PM-ICC August 2020

Change Project CBE200195

Change Project CBE200195

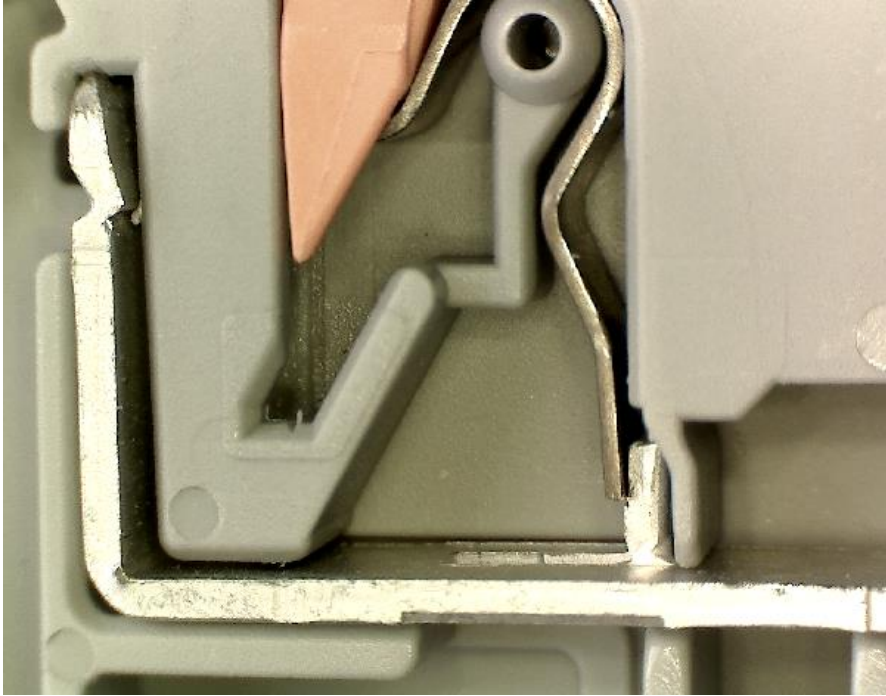
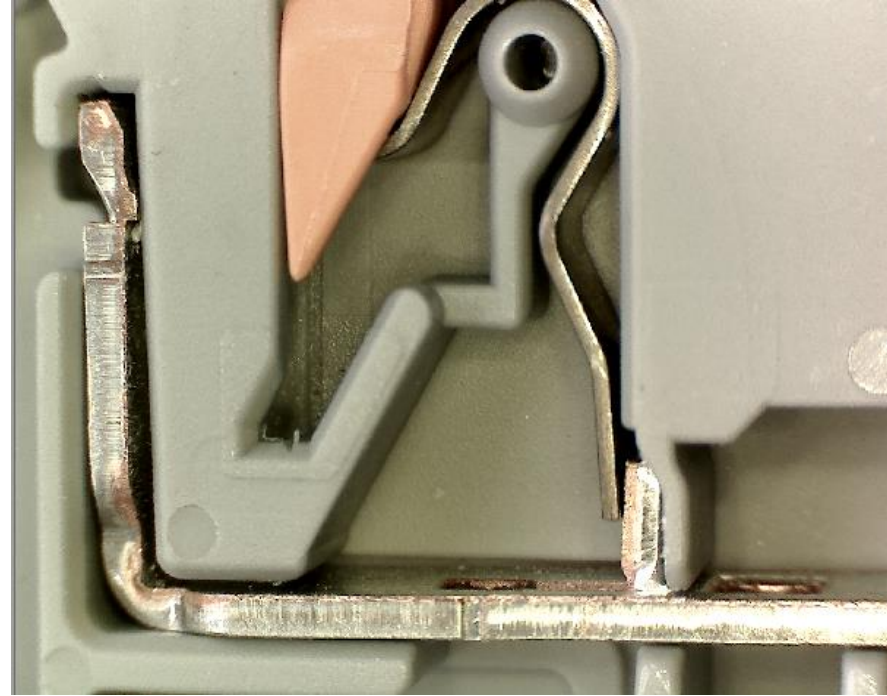
1. The current bar of the PT 2,5 I-shape design terminal block with **pre-plated** tin, the cutted side and therefore copper is visible.
2. The current bar of the PT 2,5 I-shape design terminal block with **post-plated** tin, the cutted side and therefore copper is not visible.

Old V/C post-plated

New V/C pre-plated
